The Sizewell C Project

9.10.12 Initial Statement of Common Ground - East Suffolk Council and Suffolk County Council Appendix 11A: SZC Co. clarifications in response to questions raised by East Suffolk Council and Suffolk County Council

June 2021

Figure 1 – National Noise Policy Aims as set out in the NPSE

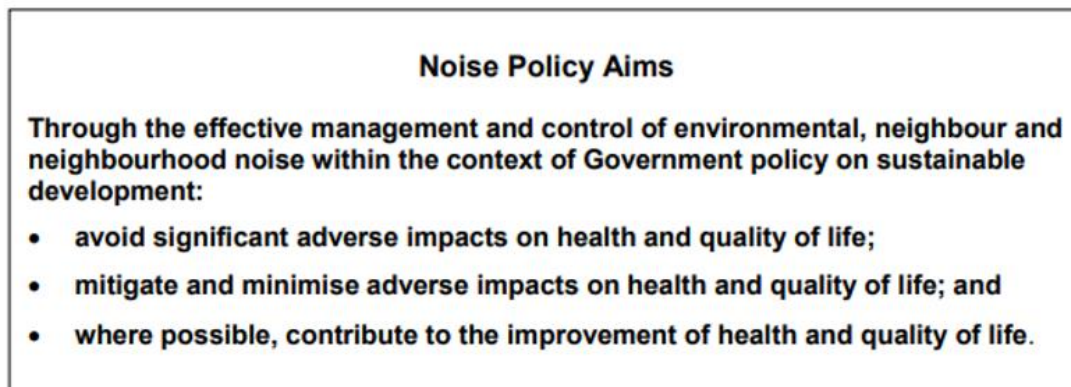
In summary, the Noise Policy Aims of the NPSE are consistent with the stated aims of NPS EN-1 and the NPSE provides very clear guidance on what action should be taken in response to potential adverse impacts (between LOAEL and SOAEL) and significant adverse impacts (exceeding the SOAEL). These aims and actions are well established.

However, paragraph 1.2.17 of Appendix 6G contradicts this by claiming that “*the concept of the SOAEL is different from the declaration of significant adverse effects in an Environmental Statement*”. No further explanation is offered and ESC disagree that there is inconsistency between the two, but would welcome clarification on this point.

3.1.1 The SZC Co. paper ‘Noise Assessment Methodology’ (see Appendix E) sets out a full explanation of the relationship between the policy thresholds of LOAEL and SOAEL, and the determination of significant adverse effects in terms of the EIA Regulations [Ref 10].
